File NO:
MODEL: Q013		Drawing NO:
TITLE:		STANDARD:
scн: V0.2	PCB: VO.2	CHECK:
DESIGN:		APPROVE:

## BASEBAND-POWER

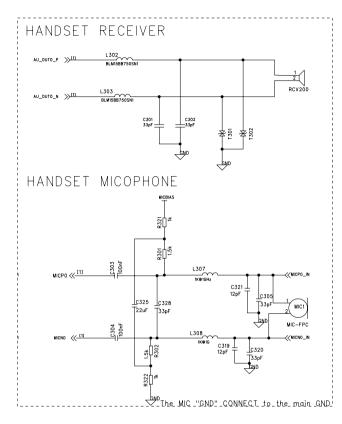
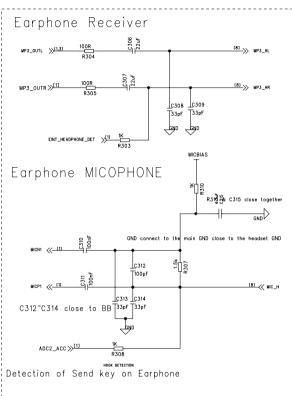
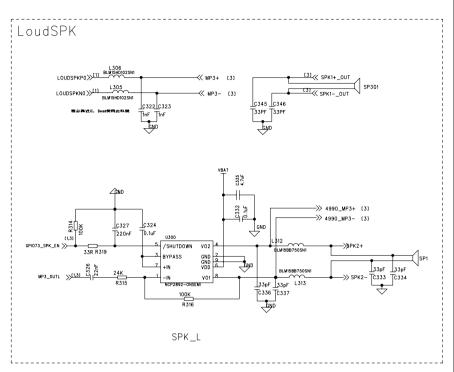
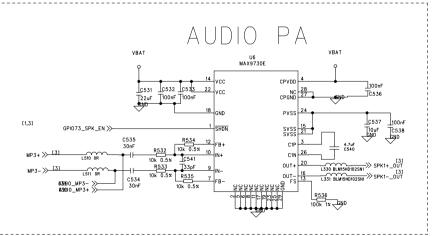
## Check, Trace 4mil is enough

LZ0701 DELETE GOLD-BATTERY: DELETE DUAL-DIODE DESIGN;

LZ0701 change L203 tobe 0603 package; LZ0716 ADD R208 OR FOR MOTOR; delete D203 add L214;
